Department of Ecology
NWP - Richland

Dear Ms. McFadden: Following are comments on the Draft Supplemental Environmental Impact Statement for the Perma-Fix Northwest draft permit renewal. The comment period is February 6, 2025, to March 24, 2025.

Figure 2. Layout of ATG Site

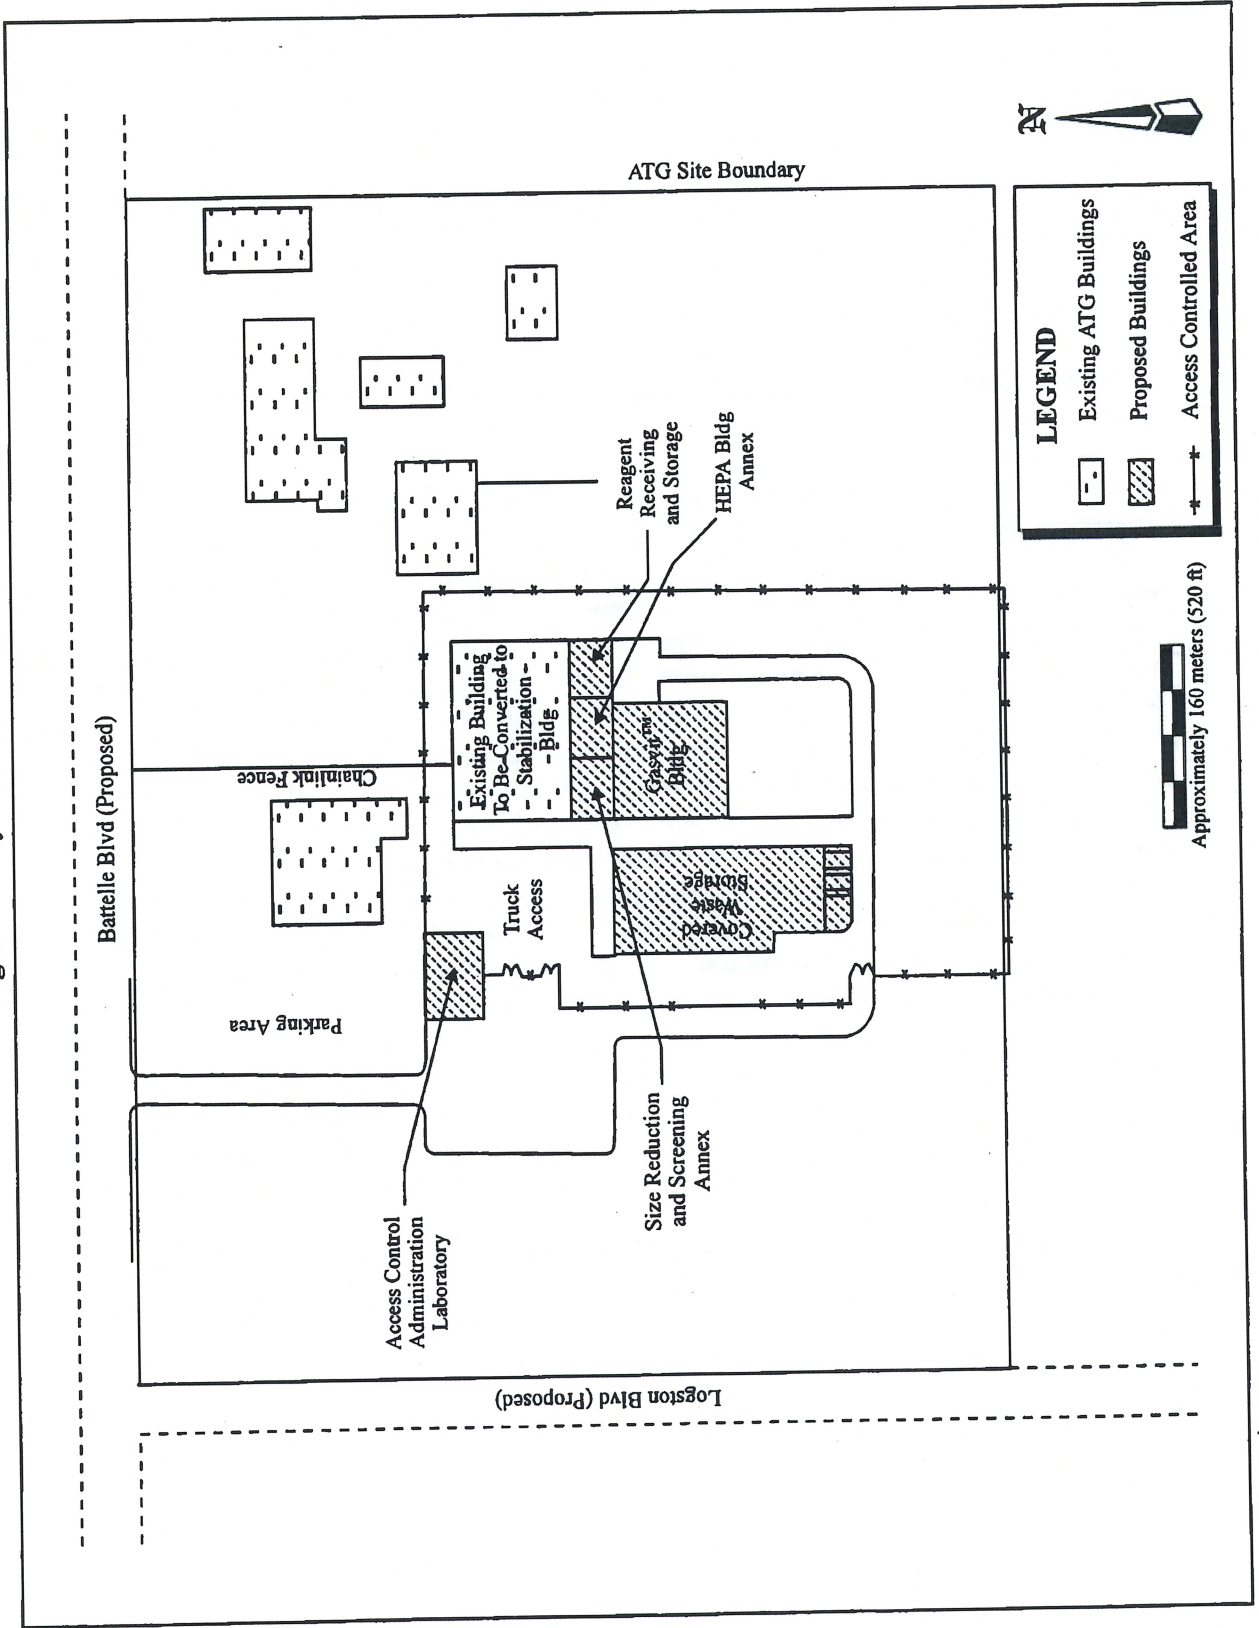
6. Chapter 2, Figure 4. This figure omits the building legend from the referenced Part A Form, making it difficult to figure out what is going on (a legend should be added). Further, please compare Figure 4 to the Figure 2 Layout from the 1998 EIS (Enclosure No. 1). Of note is that pretty much NOTHING is the same. As a result, this SEIS should not be a supplement, but rather a stand-alone EIS.

Figure A-3 – Facility Plot Plan (SITE-CIVIL-001)

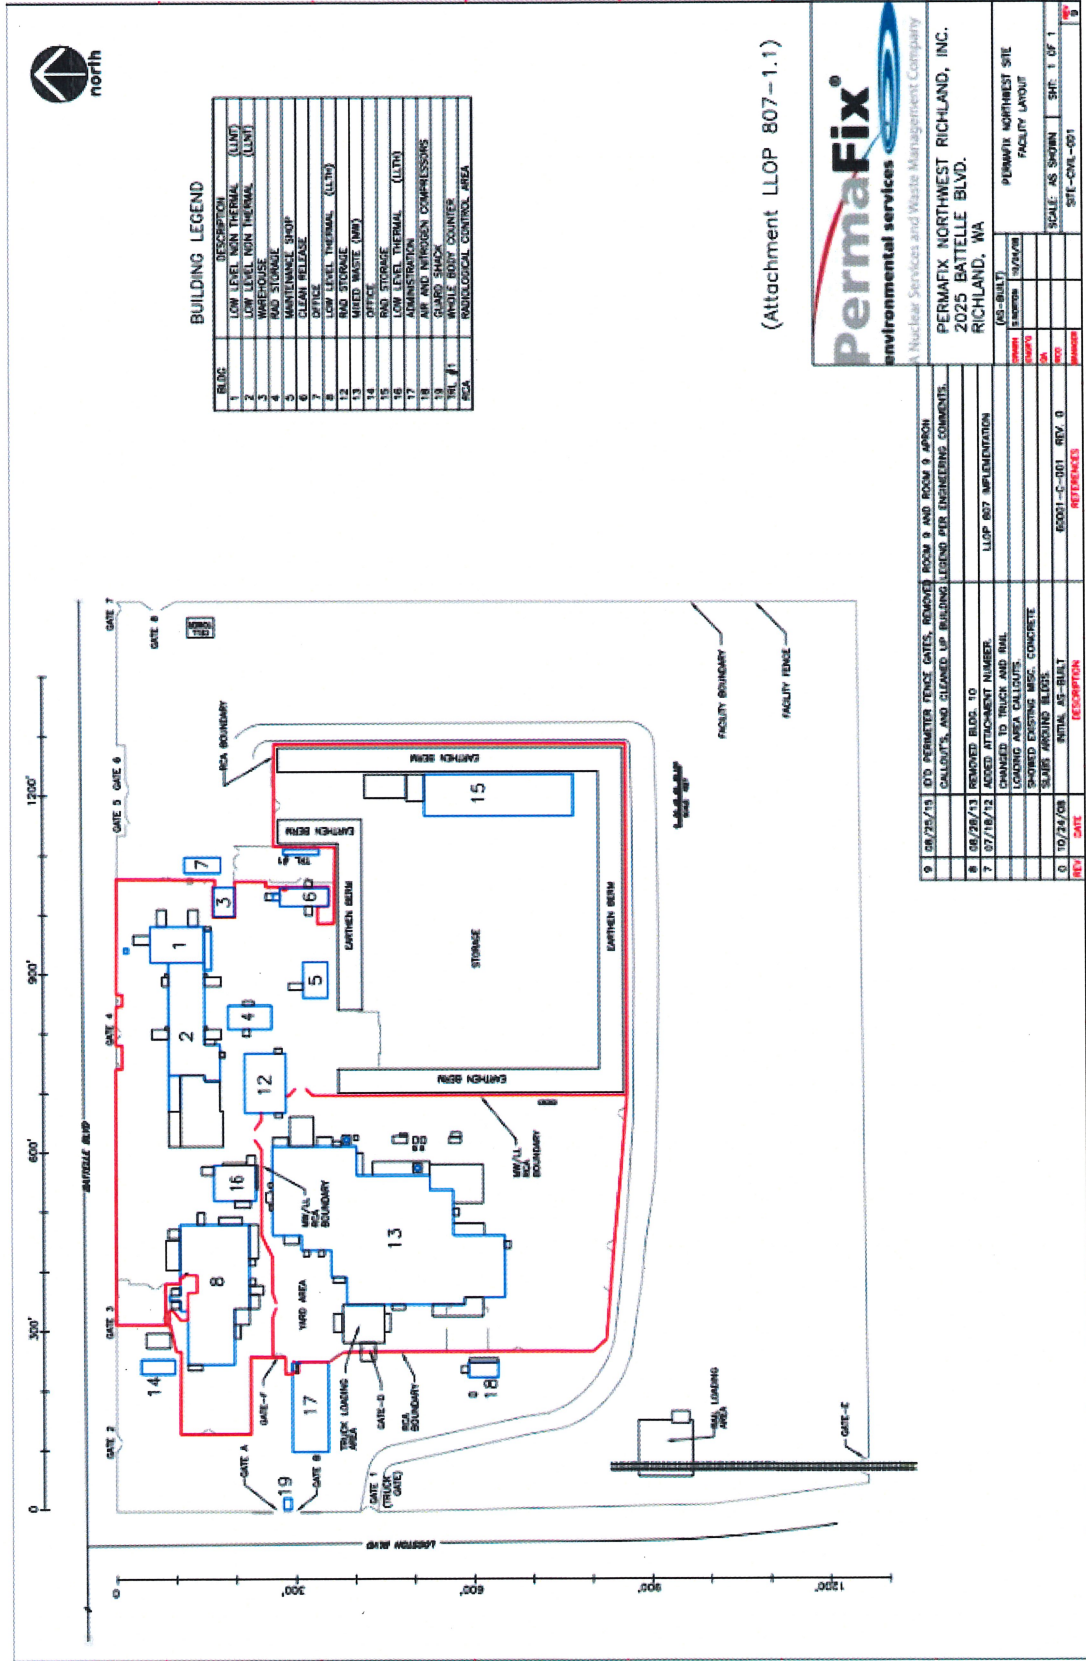
2024 Looks A Lot

Different Now
